**An Bord Pleanála Ref: PA 0034**

**Proposed Alexandra Basin Redevelopment**

**Reply to Request for Further Information**

**Fig. 2.1**

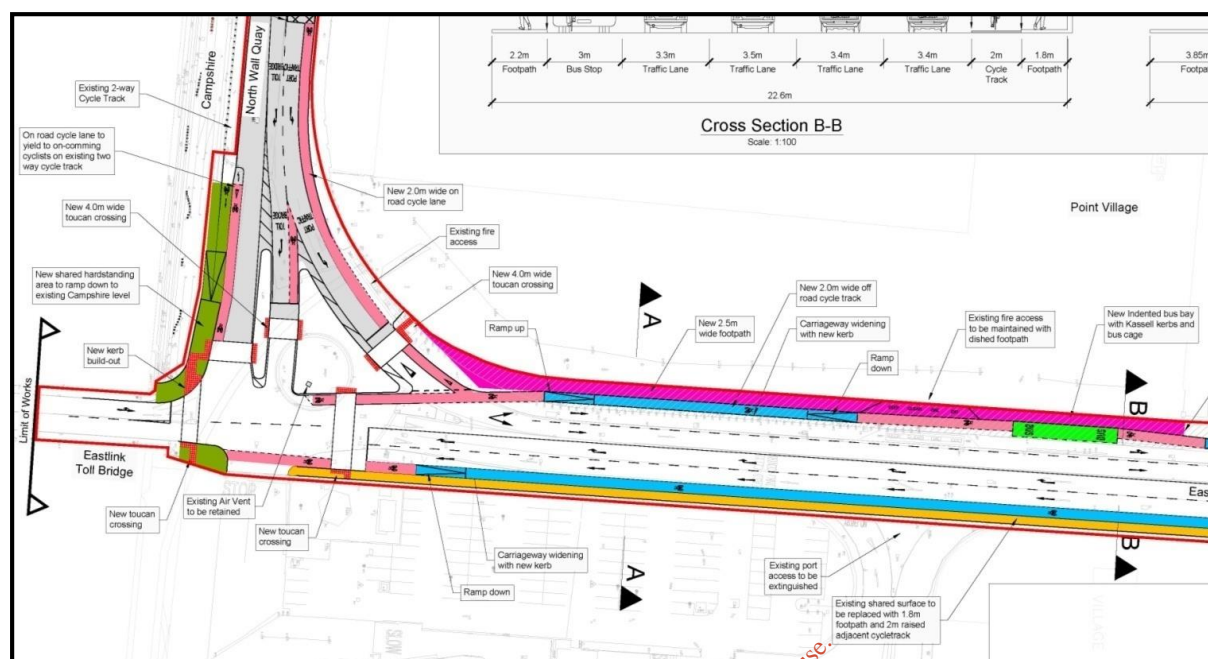
*The Board is not satisfied that the quality of linkage between the proposed development and the City has been adequately demonstrated. The applicant is requested to submit details supported by appropriate drawings, clearly illustrating how it is proposed to improve integration between the proposed development and the City. These details should address in particular the following:*

- *Pedestrian connectivity between the Campshire/Quay and Cruise area/ Interpretative zone;*
- *Connectivity between the cruise area and Luas/North Docklands; and*
- *Connectivity for bus traffic to the amenities of the City, which might consider more direct alternatives to the proposed Promenade Road Route.*

Fig.2.1 below is an extract from the DCC/Arup drawing (Drg. Ref. No.TO100-01) relating to the pertinent section of the improvement scheme at the current Point/3Arena roundabout showing the planned pedestrian crossings.

The plan shows a signalised junction in place of the existing roundabout incorporating signalised pedestrian and cycle crossings at the northern side of the East Link Toll Bridge thus creating a direct and safe pedestrian link between the Campshires and the Cruise/Interpretive area.
